# TOBIN

**Case Number ABP – 321522-24**  
**Scart Mountain Wind Farm**  
**Response to Submissions Report**

Ireland  
**FuturEnergy**

**Figure 2-1 Updated version of Figure 3-5 in Chapter 3 of the Submitted EIAR (Consideration of Alternatives) to provide clarity on the alternative routes being assessed. Title: Alternatives to the proposed Grid Connection Route**

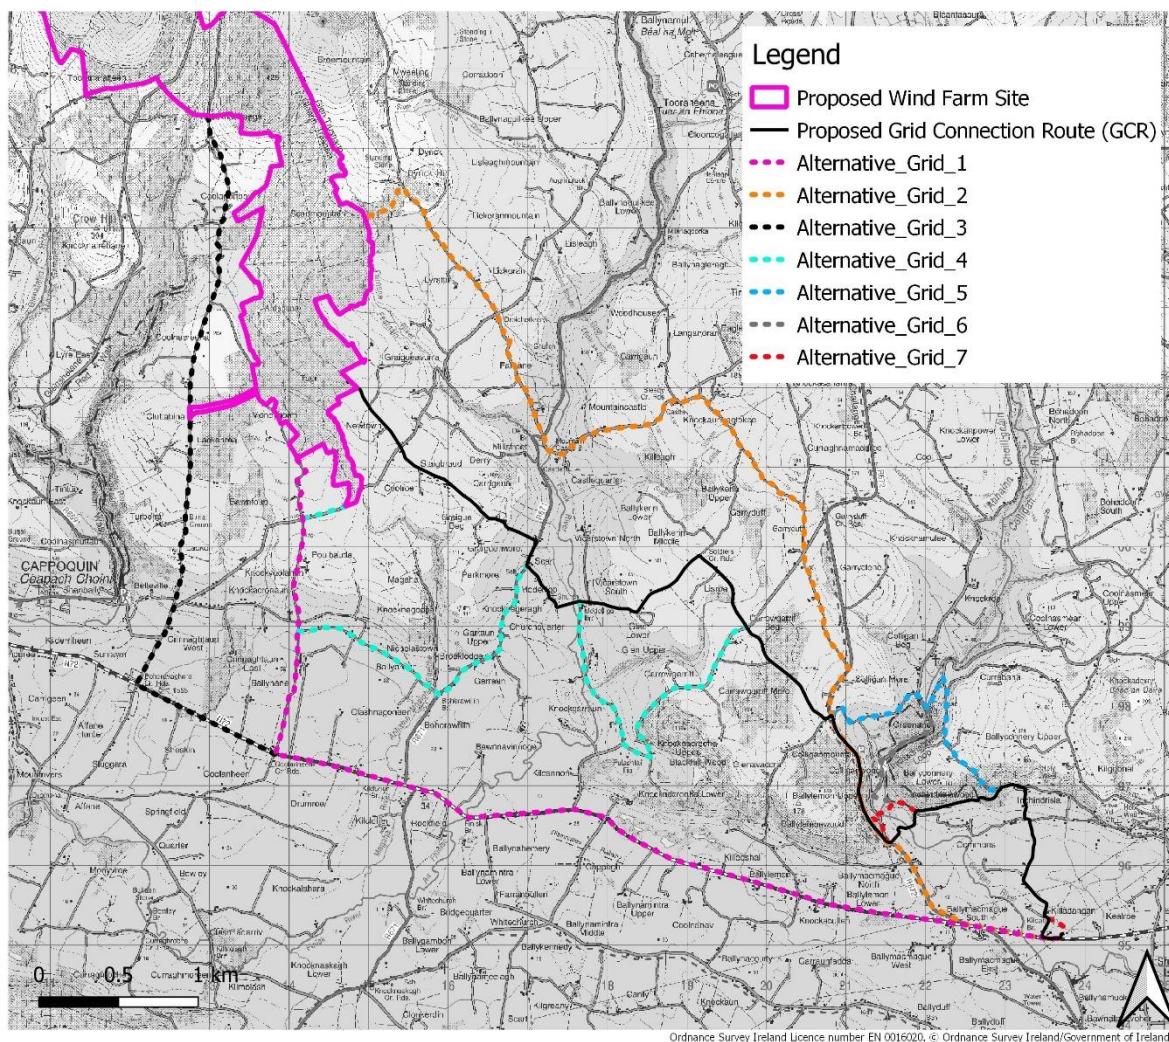
- Alternative grid connection routes mostly via the N72 (see black and pink in Figure below)
- Alternative grid connection routes via local/regional roads from the eastern side of the proposed wind farm site (see orange in Figure below)
- Alternative grid connection routes – short sections (see light blue, grey and dashed red in Figure below)
- Alternative grid connection routes – (see turquoise in Figure 2-1 below)

It should be noted that Figure 3-5 was incorrectly labelled as Figure 3-4 in the EIAR due to a typographical error, and the routes did not all display clearly in the map. They are shown more clearly in Figure 2-1 below. The findings of the assessment however were unaffected by the figure issue and they remain valid. The proposed grid connection route is the most appropriate option for the route.

Figure 12-5 Schematic diagram of multiple reflection paths for sound propagation across concave ground

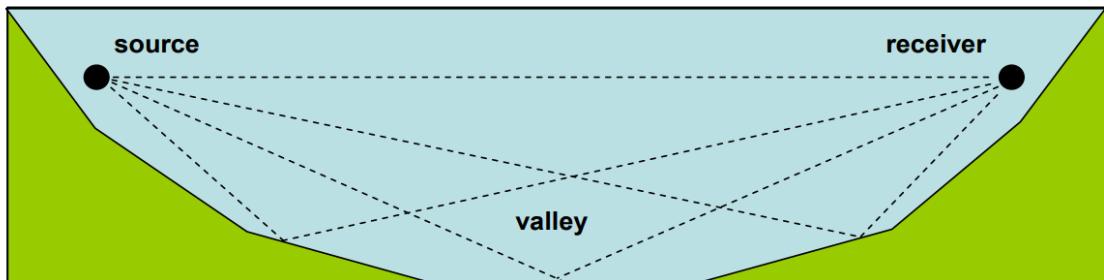
To address specific concerns raised in Observation no. 23<sup>46</sup> regarding noise propagation in the vicinity of Knocknamork Mountain the following additional clarifications are provided:

The IOA GPG guidance recommends that a correction be applied for propagation across a valley, i.e. a concave ground profile, or where the ground falls away significantly, between the turbine and the receiver location. Figure 12-5 taken from IOA GPG, illustrates the principle of acoustic reflections between the source and receiver across a valley or concave terrain.

The noise prediction calculations have been undertaken using Tailte Éireann ground topography data to account for noise propagation effects in line with IOA GPG guidance and the ISO 9613-2 Standard. The noise prediction software, *iNoise*, described in Section 12.3.5.1 of the

Figure 12.1 Excerpt from Appendix 2 of the current Renewable Energy Strategy showing updated wind energy classification areas in relation to the proposed project.

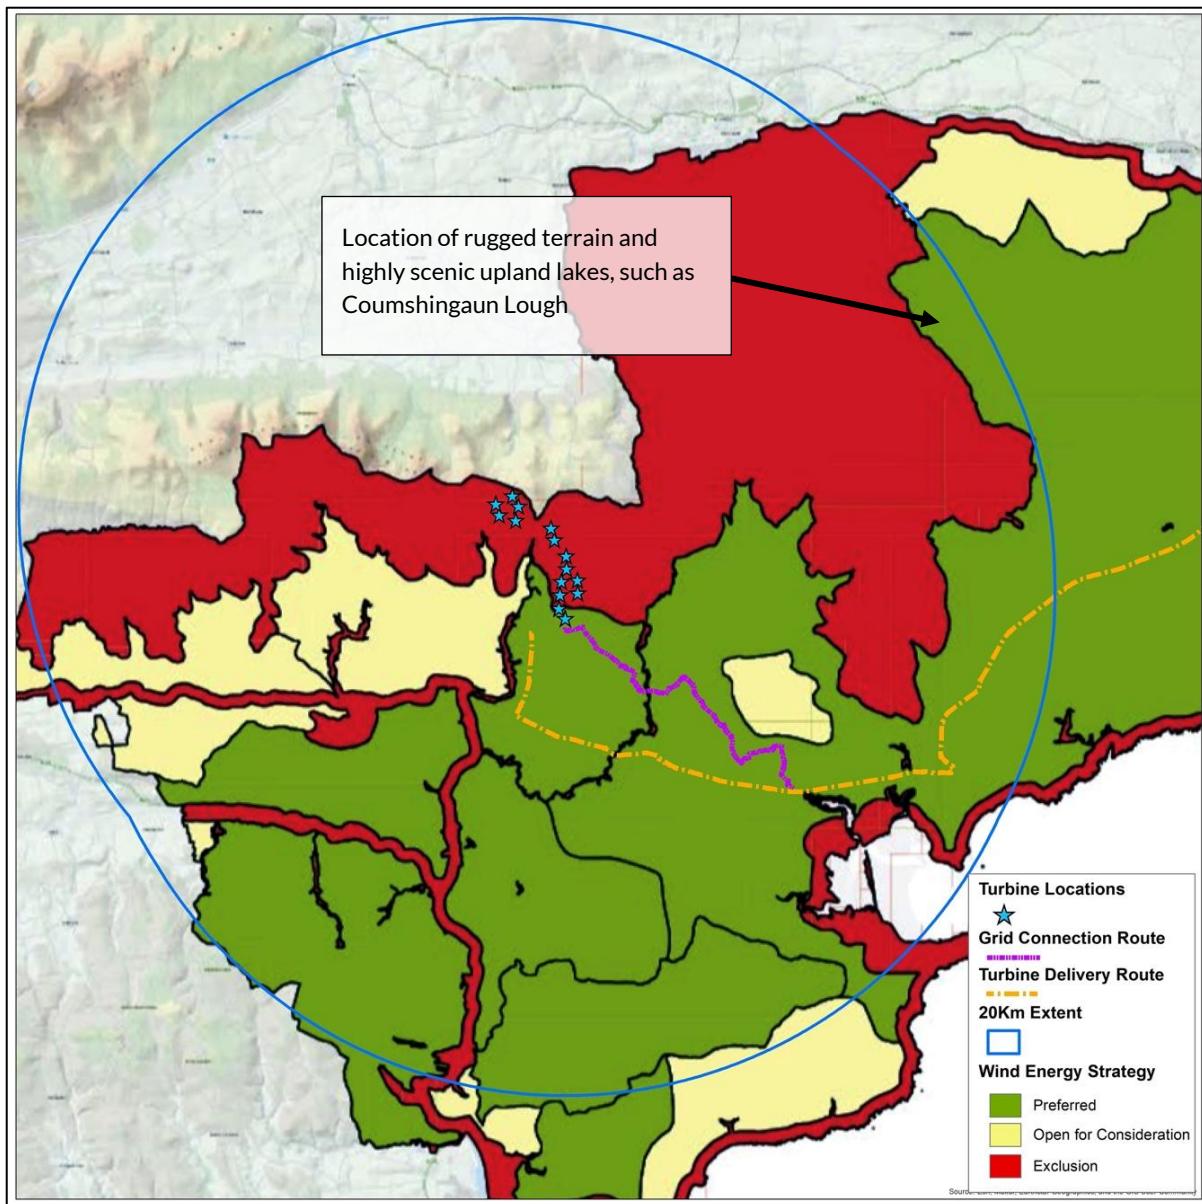
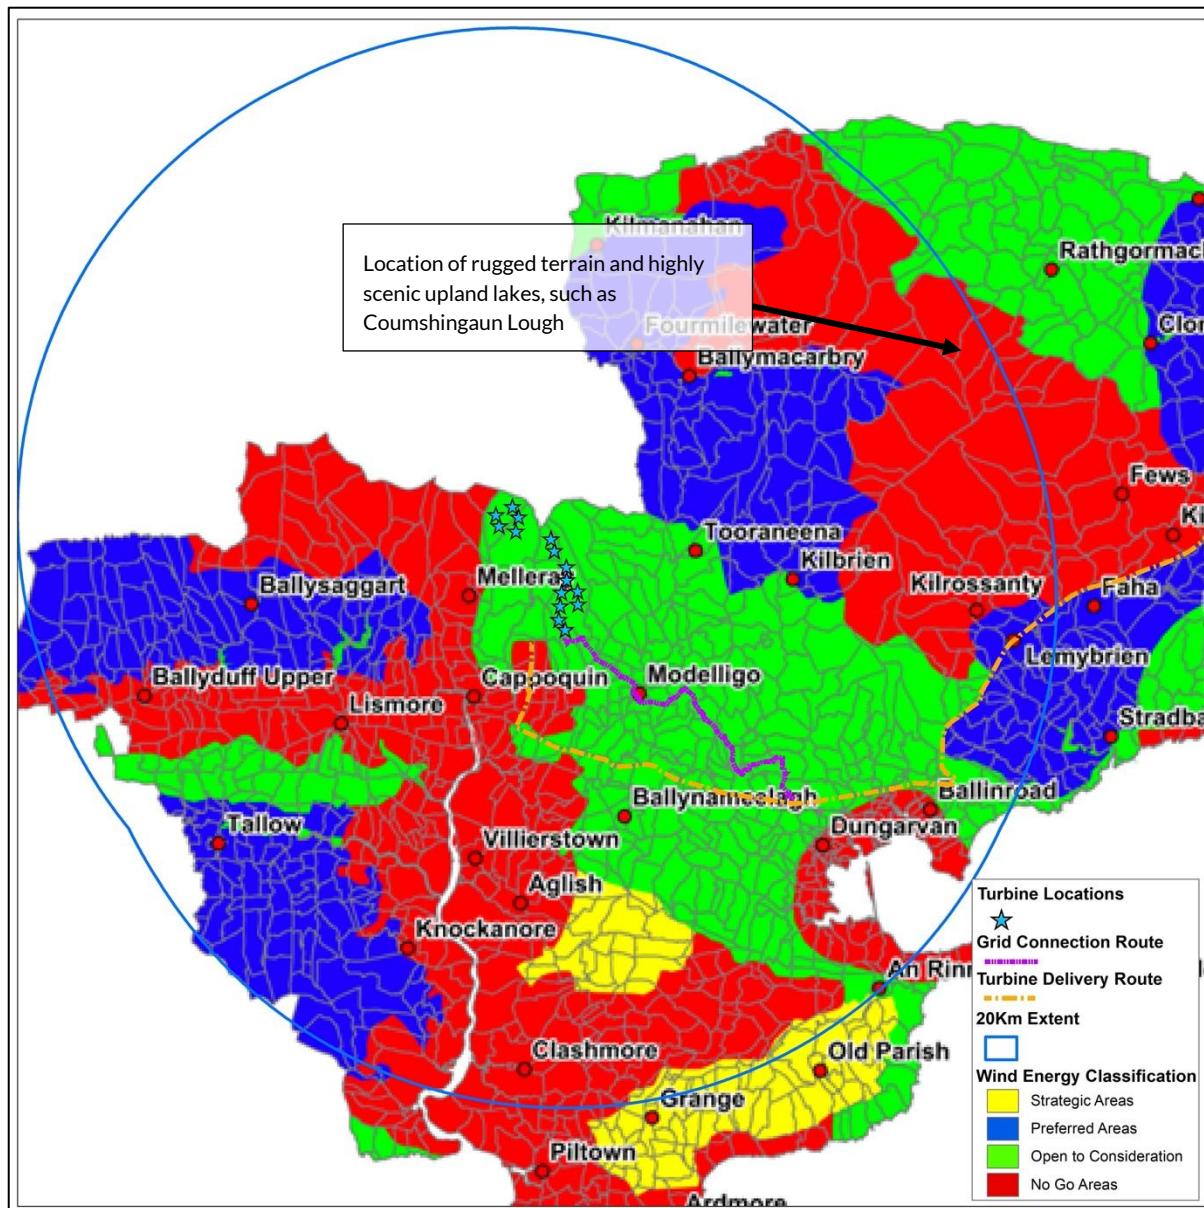
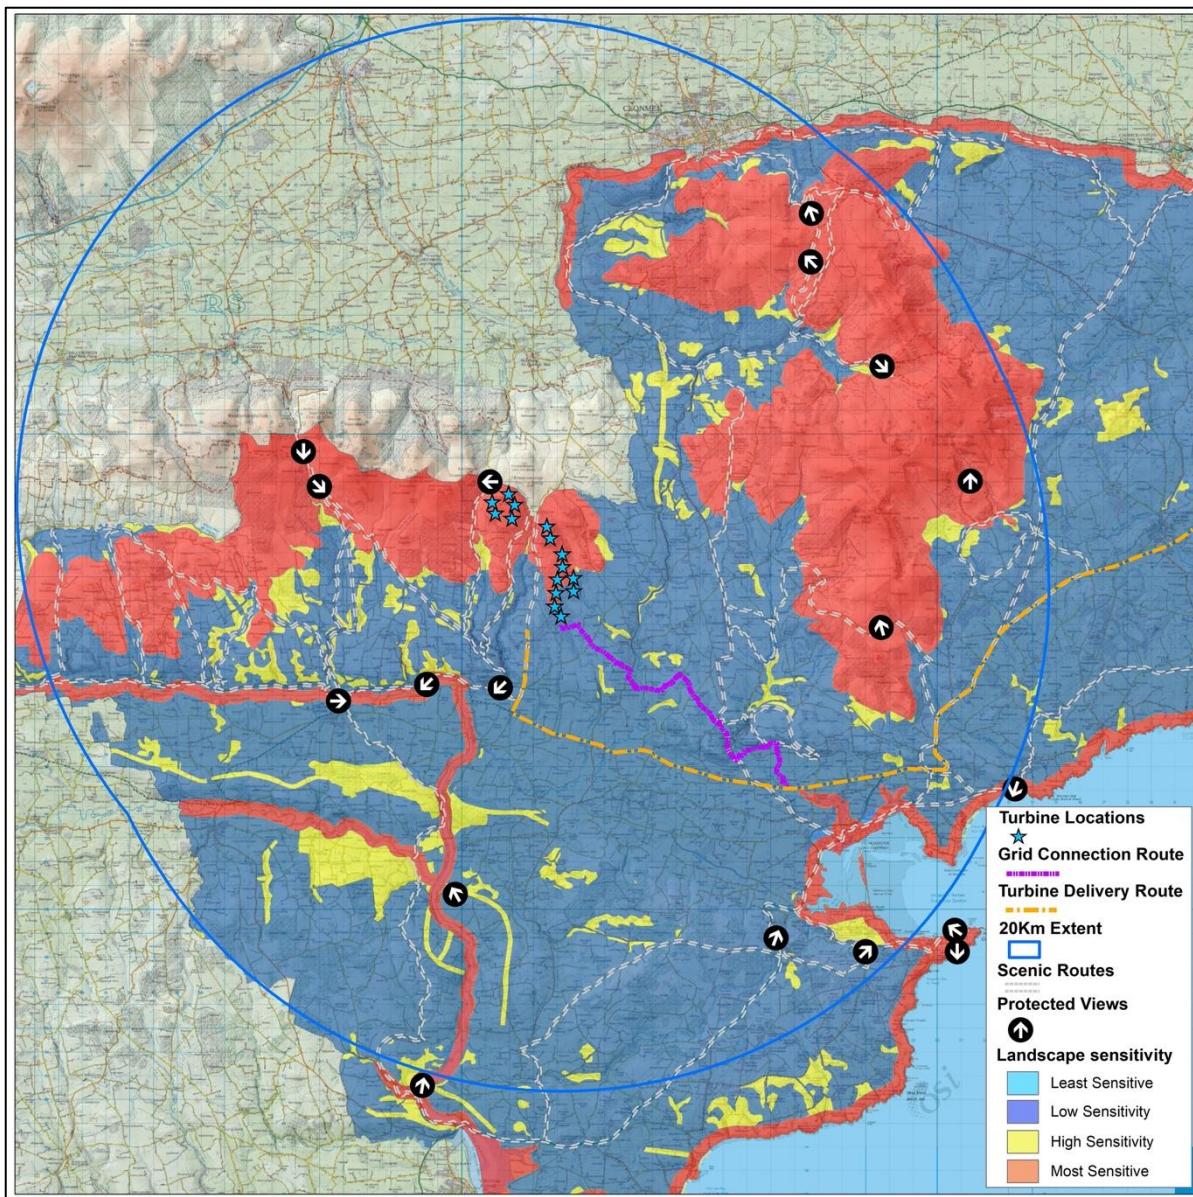
It is noted that a common theme in the observations relates to the Proposed Project’s location within a ‘Most Sensitive’ landscape classification in the current Waterford County Development Plan (CDP) 2022-2028. The submitted LVIA fully recognises this designation, which is indicated in the Landscape Policy, Context and Designations section of the report in subsection 13.3.2 and shown on Figure 12-3 below. However, as noted in the submitted assessment, both the renewable energy classifications and landscape sensitivity classifications in the current CDP encompass a degree of ambiguity and are contradictory, especially with regard to the previous designations and classifications provided in the previous Waterford County Development Plan 2011-2017 (as extended). Indeed, as stated in the submitted assessment:

*Whilst the current renewable energy strategy for County Waterford identifies part of the proposed project within an ‘no-go’ area, this is in stark contrast with the previous version of the Waterford Renewable Energy Strategy (formed part of the previous Waterford County Development Plan 2011-2017 (as extended)), which designated the site and surrounding landscape as an area ‘Open to Consideration’ in relation to wind energy development (refer to Figure 12.1 and Figure 12.2 below). It is also worth noting that this wind energy designation changed to a ‘Preferred Area’ to the northeast of the site. Whilst the current Renewable Energy Strategy identifies some rationale for the updated wind energy classifications throughout the county, it is still highly ambiguous how areas once classified as ‘Open to Consideration’ and ‘Preferred’ for wind energy development can now be classified as ‘exclusion areas’. Whilst there is some consistencies with the updated ‘most’ sensitive landscape classification in the current CDP and the new ‘No-go’ area, there is no clear reason why the southern extent of the site, which is contained in a ‘Low’ landscape sensitivity classification is also located within a ‘No-go’ area.*

*Further clear contradictions in the updated wind energy classifications are also noted throughout the Comeragh Mountains. The eastern flank of the Comeragh Mountains comprises some of the most visually susceptible rugged ridgelines, steep rocky escarpments and highly scenic upland lakes, such as the Coumshingaun Lough. The previous wind energy strategy included this entire part of the Comeragh Mountains as a 'No-go' (refer to Figure 12.2), which is clearly associated with its highly sensitive nature and limited capacity to accommodate development of any type. In contrast, much of the eastern flank of the Comeragh Mountains is now classified as 'Preferred', (refer to Figure 13.6 of EIAR) and no logical explanation is given regarding this new positive wind energy designation.*

*Overall, Waterford has considerable potential to accommodate wind farm development along less visually susceptible foothill landscapes located throughout both the Knockmealdown Mountains and Comeragh Mountains including the site of the proposed project. Instead, the current Wind Energy Strategy has done a direct U-turn by classifying the more robust transitional landscapes as 'No-go' and some of the most highly sensitive and visually susceptible landscape areas as 'Preferred' wind energy classifications, without any clear or logical explanation.*

**Figure 12-4 Existing Barranafaddock turbines located along the south-western transitional foothills of the Knockmealedown Mountains**

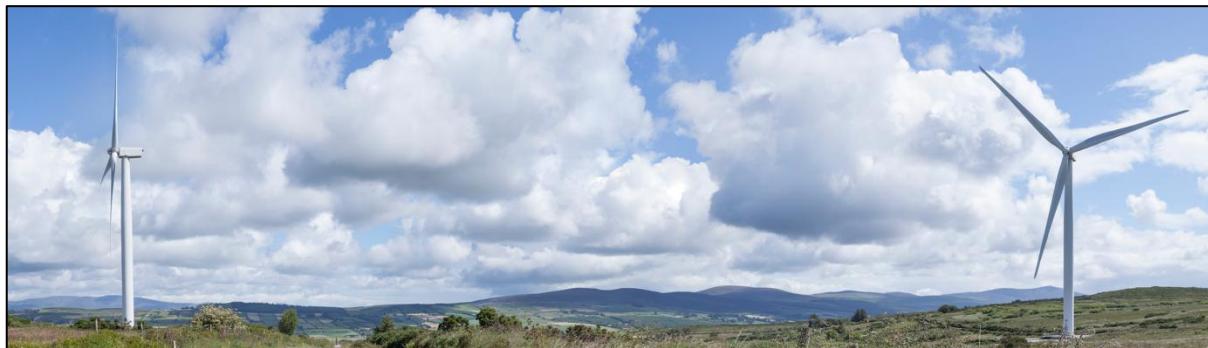
Overall, the Proposed Project will contribute to some degradation of the character of the surrounding landscape, which is accounted for in the submitted LVIA. However, with regard to the most susceptible parts of the surrounding landscape, such as the more remote upland areas to the west and in the wider eastern extent of the study area, the Proposed Project will have a more limited effect. This is principally as the proposed Project is contextually separated from those areas, being situated instead within the more robust transitional foothill landscape. It is these foothill landscapes that can accommodate a more notable degree of change than the more highly susceptible, distinct and remote upland areas, which is evidenced by the fact that the

existing Barranafaddock turbines are contained within an almost identical such landscape context, in the south-western foothills of the Knockmealedown Mountains in the wider western extent of the study area (see Figure 12-4 below).

**Figure 12-5 Image showing the location of the proposed turbines in relation to the Glenshelane Trails**

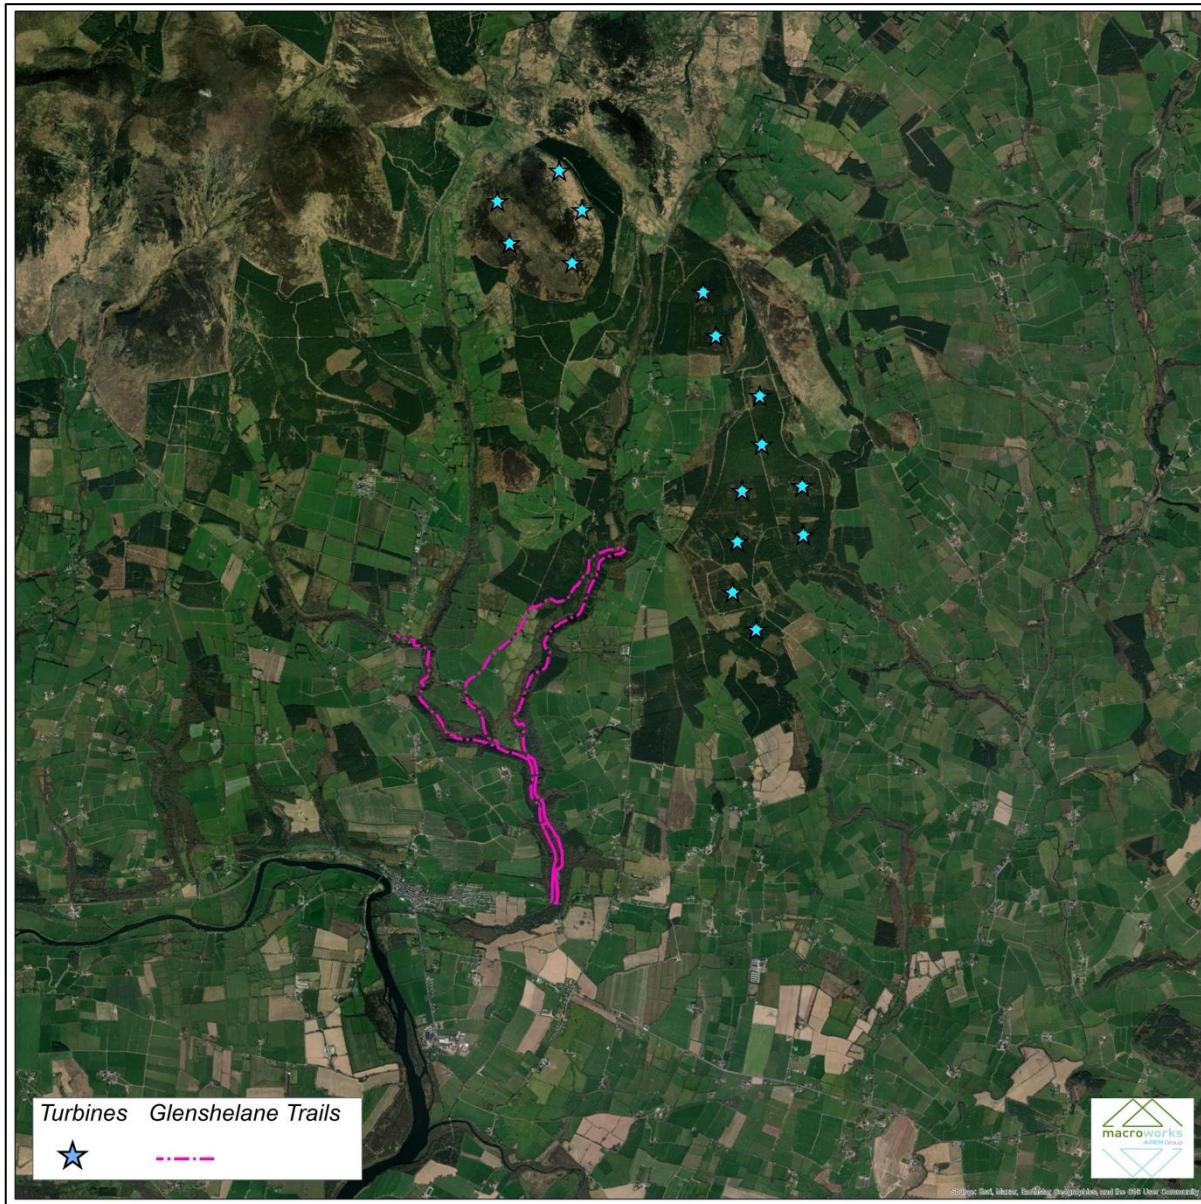
It should be noted that the Glenshelane Trails were referenced in several observations made with respect to the Proposed Project. The Glenshelane Trails are the nearest amenity feature to the proposed turbines and follow the corridors of both the Glenshelane River and the Glenafallia River (refer to Figure 12-5). Whilst the ZTV identifies the potential for comprehensive visibility in the valley surrounding the Glenshelane River, the immediate corridor of the river, which the trails follow, encompasses a much more limited degree of visibility, ranging from no turbine visibility to theoretical visibility of between one and six of the proposed turbines. As noted in the submitted LVIA, the ZTV mapping is based on a bare-ground scenario and does not account for screening in the form of existing vegetation and surrounding built development. With regard to the aforementioned trails, these are contained within an area

cloaked in dense woodland, which truncates any sense of openness or views of the wider landscape. In this regard, a viewpoint for assessment from these trails was scoped out due to the limited visibility here. Overall, it is not considered that the proposed turbines will result in any notable visual effects at the amenity receptor. Indeed, the turbines will likely be fully screened aside from some brief residual glimpses through gaps in the surrounding dense vegetation.
